## *Technical Bulletin 140*

### Upstream vs Downstream Pressure Tap Explanation

Version 1.0, Revision AA (22 June 2006)

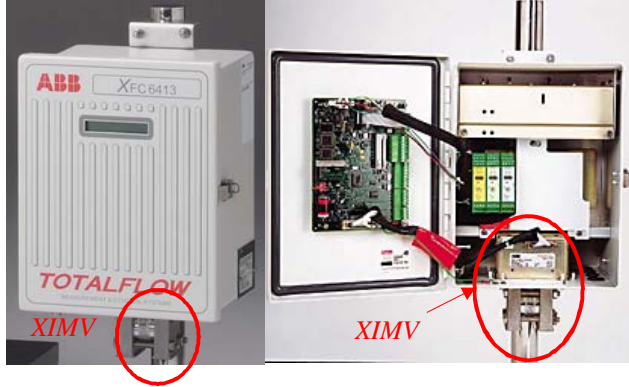
Either the new XIMV utilizing an upstream static pressure sensing element or the AMU which primarily used a downstream static pressure sensing element is illustrated in the picture above. Use the included table to determine if your transducer is utilizing an upstream or downstream sensing element.

Close-up picture of an AMU (part# 2015285-xxx) which utilizes a downstream static pressure sensing element (see table attached to determine if a particular part number incorporates and upstream or downstream static pressure element).

Close-up picture of an AMU or XIMV (part# 2015332-xxx) which utilizes an upstream static pressure sensing element (see table attached to determine if a particular part number incorporates and upstream or downstream static pressure element). A note has been included on all XIMV transducers indicating that these units have an upstream static pressure element and that the "tap location" set by PCCU must match the static pressure location.

After verifying your transducer type, use PCCU to change tap type if required
